CALIFORNIA COASTAL COMMISSION

STAFF REPORT: PERMIT AMENDMENT

APPLICATION NO.: 4-99-169-A1

PROJECT LOCATION: 25126 Pacific Coast Highway, City of Malibu (Los Angeles County)

EXHIBIT NO. 5
APPLICATION NO.
4-99-169-A1
SITE PLAN DETAIL

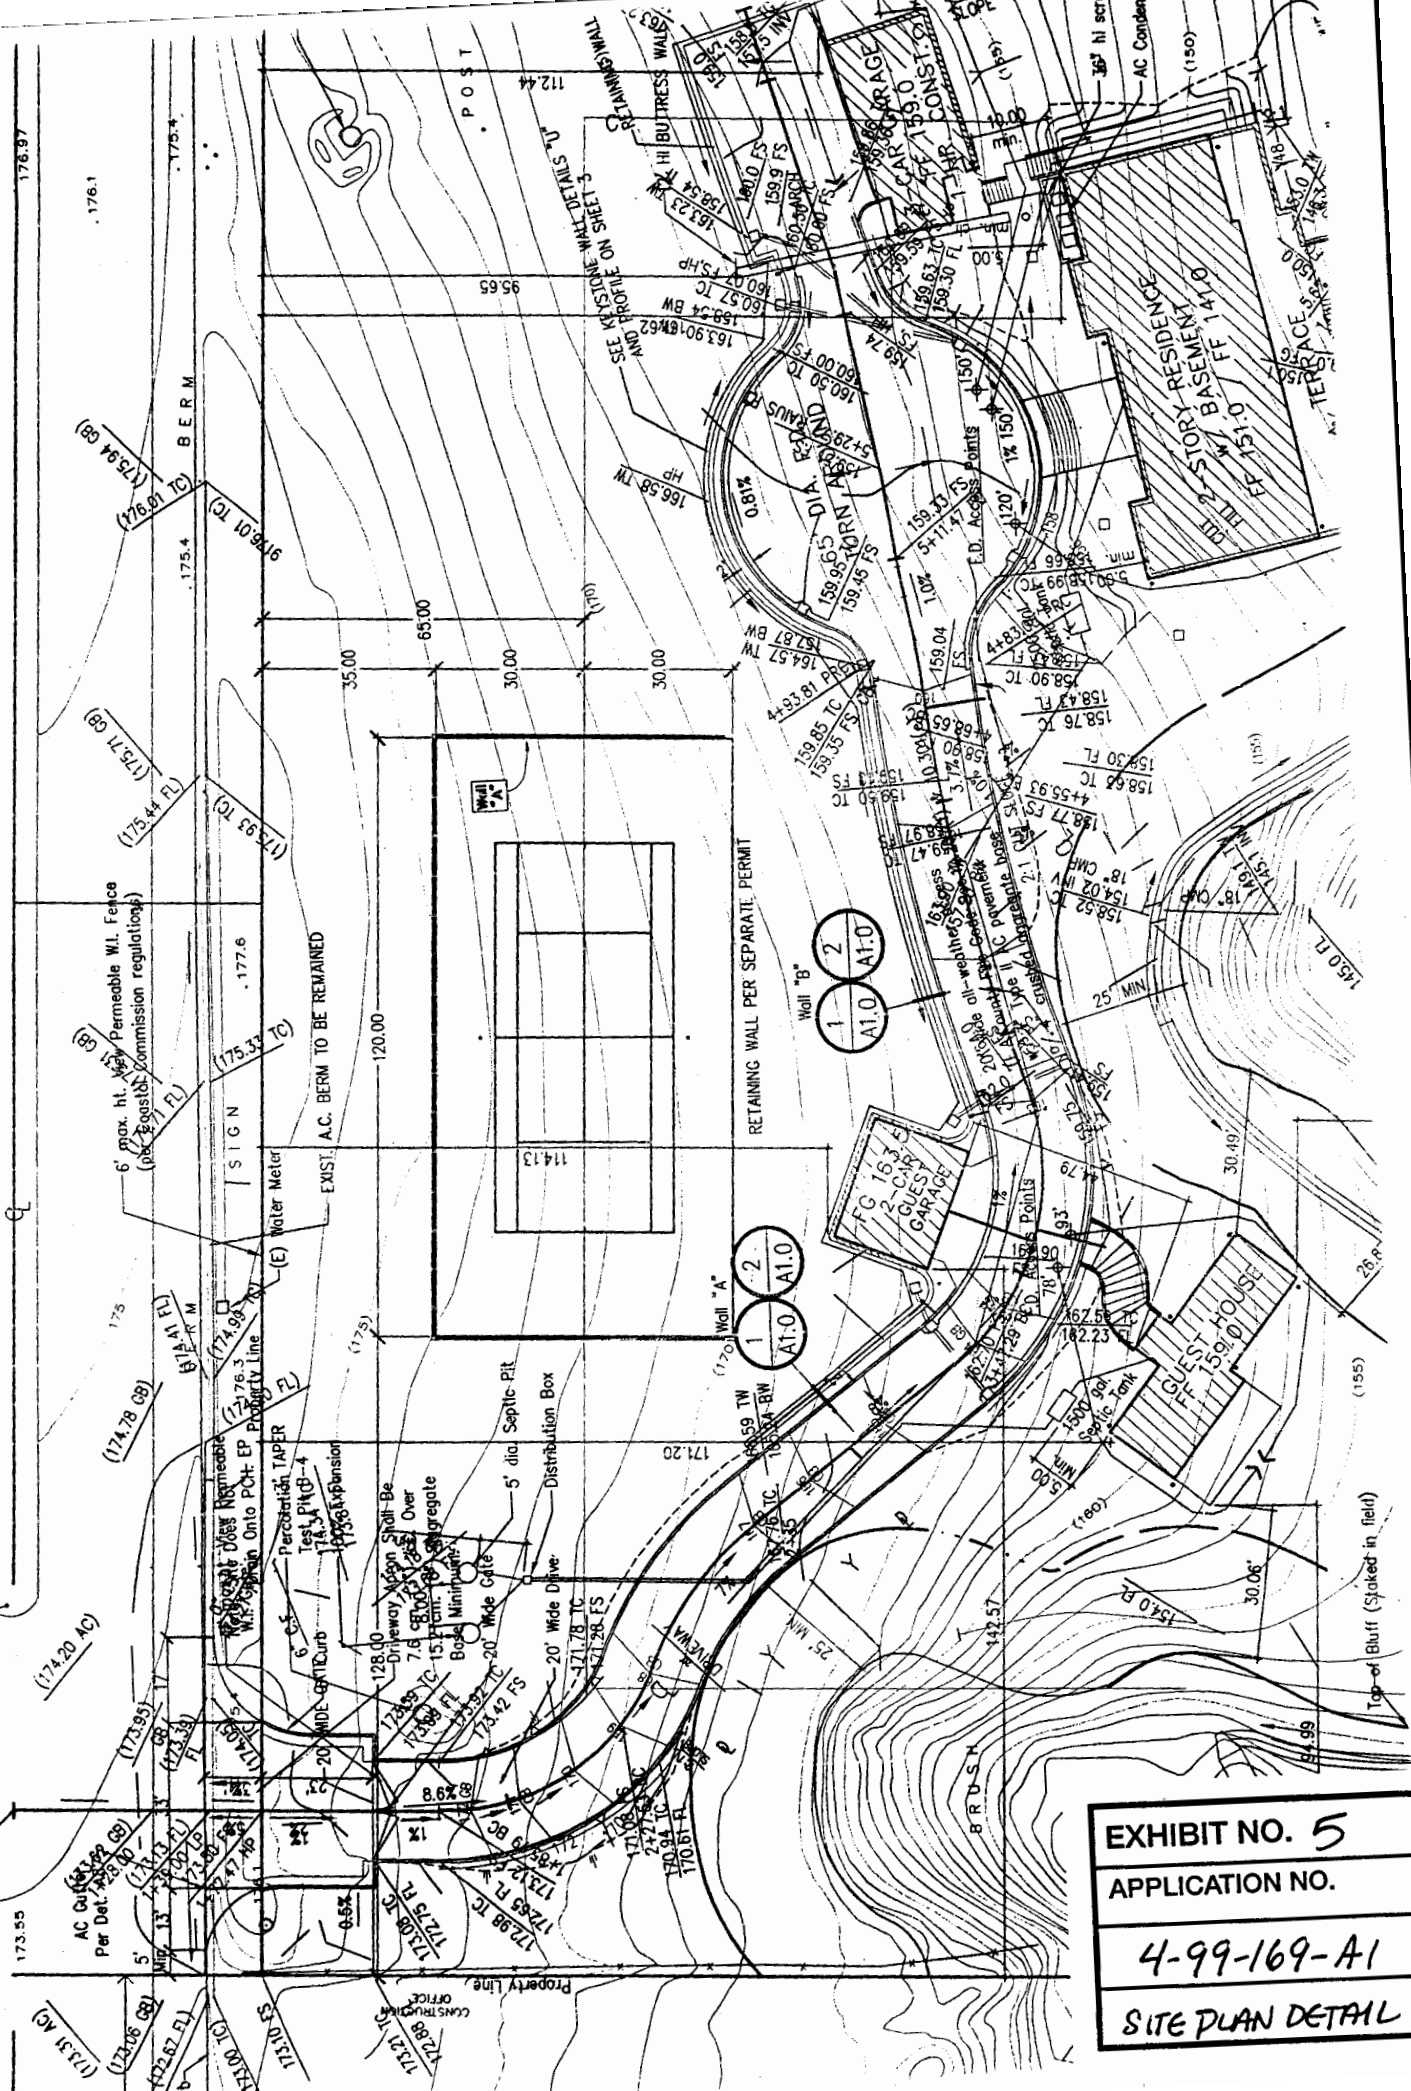
The proposed tennis court is visible from Pacific Coast Highway and is located within existing ocean view corridors. The proposed court is to be dug into the gently descending slope between the existing developed area of the site and Pacific Coast Highway. The court is to be supported on three sides by a retaining wall, which will reach up to six feet in height on the court's upslope edge, and taper to finished grade (171 ft. asl) on either end. The proposed tennis court and retaining wall thus do not exceed the 177 ft. limit required by Special Condition One (1) of the underlying permit, although the retaining wall exceeds the road grade of Pacific Coast Highway by 2 feet, inconsistent with Policy 6.17 of the Malibu LCP. More significantly, the proposal also includes construction of a six foot high visually obtrusive chain link fence atop the retaining wall, thus raising the height of development to an elevation of 183 feet asl.

Construction of the proposed project, particularly the chain link fence, would obscure the ocean view corridors between existing structures on the site, significantly diminishing bluewater views from Pacific Coast Highway, by adding a second line of fencing parallel to the visually permeable wrought iron fencing previously approved under CDP No. 4-99-169. (As noted in Section A. above, an unpermitted chain link fence was constructed along the northern property line in lieu of the permitted fencing. This matter has been referred to Commission Enforcement staff.) Policy 6.15 of the Malibu LCP prohibits fencing from blocking views from scenic roads to scenic areas.

EXHIBIT NO. 6
APPLICATION NO.
4-99-169-A1
GRADING PLAN

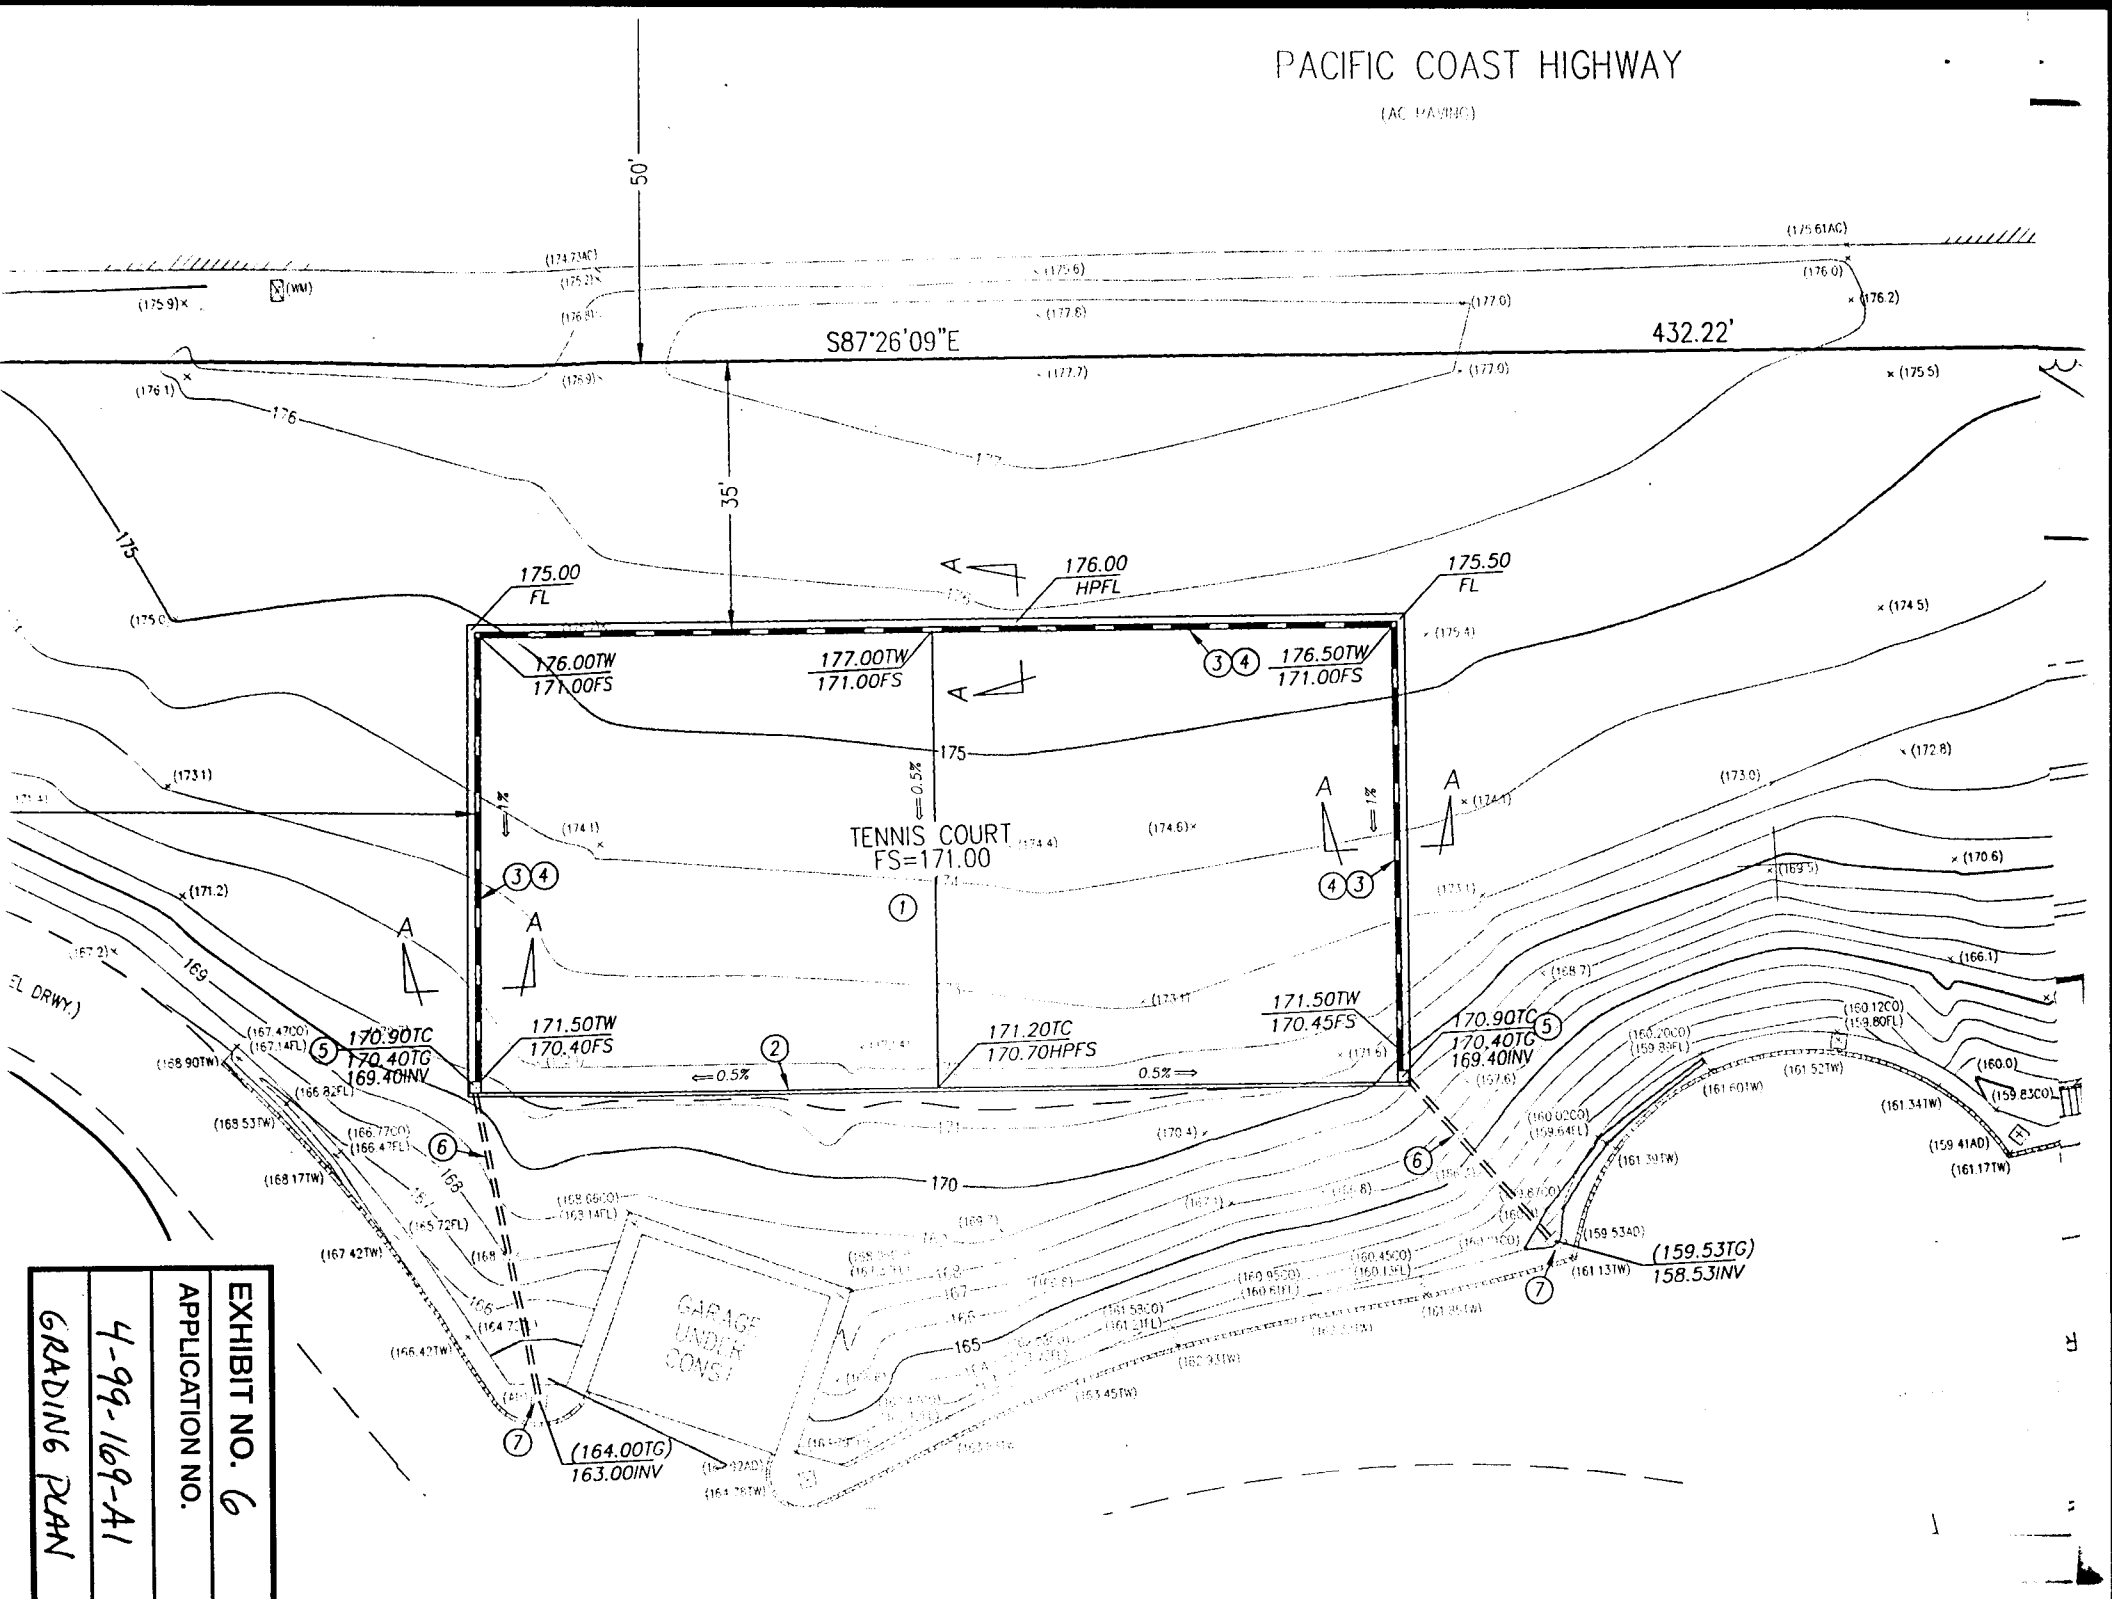
In addition, Policy 6.9 of the Malibu LCP requires structures to be clustered to minimize site disturbance and development area. The proposed tennis court extends development into a new area of the site and increases the already considerable development footprint by 7200
